Technical Bulletin

DP02	TB0031-2008	Elan Motorsports Technologies	
From:	Chip Lewis		
Subject:	<i>Nose Blanking Panel Option – Revised Opening</i>	Date:	September 10 th , 2008

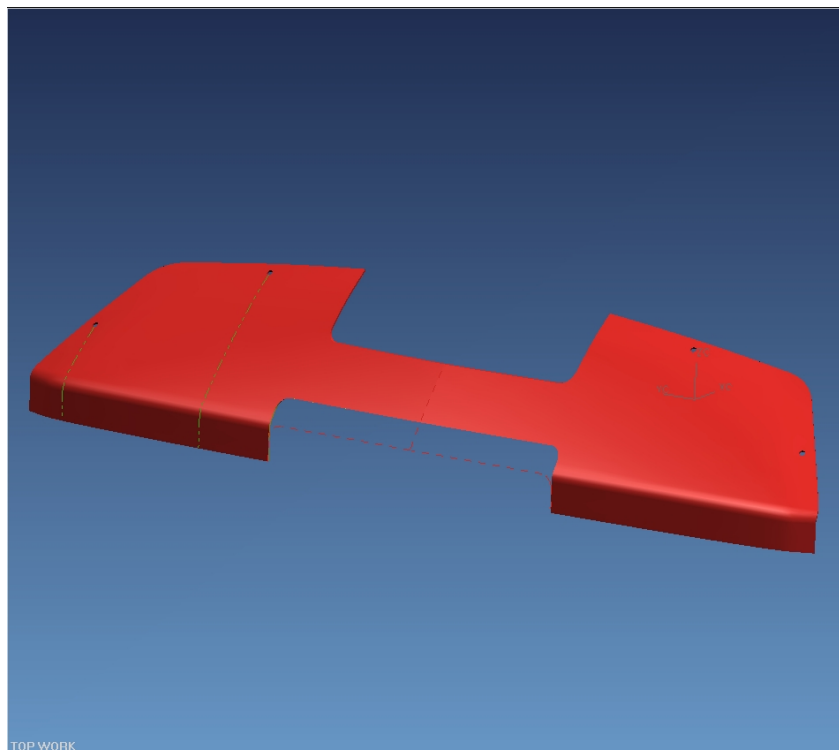
Elan Motorsports Technologies have allowed an optional increase in the opening of the DP02-40-047 nose blanking panel. The revised opening can be 1" higher than the scribe line in the panel. The maximum dimensions are 2.5" high by 13.0" wide, with the opening centered symmetrically in the panel. The maximum area must be used in a contiguous opening, with a generally rectangular shape.

Note: This nose blanking panel is a homologated component and is the only version that can be used.
